No. 86-7

- A. TR/TRS Exhaust Tube Missing on Gimbal Housing Assembly.
- B. TR/TRS Power Steering Control Valve Grease Fitting

A. TR/TRS EXHAUST TUBE MISSING on the GIMBAL HOUSING ASSEMBLY

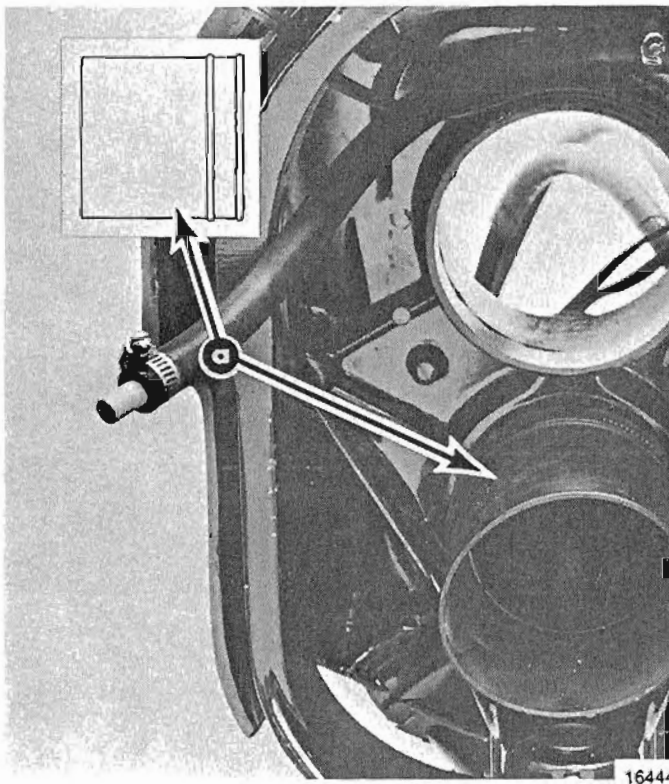
On some TR/TRS gimbal housing assemblies, the exhaust tube (a) was not put on the gimbal housing in production. If the exhaust tube is missing, you would detect a louder exhaust noise at idle with the drive unit fully down. The following serial group is affected A587717 thru A610971.

Order part number 78632A1 tube and clamp 54-38889 and install. Submit warranty claim to your regional service center.
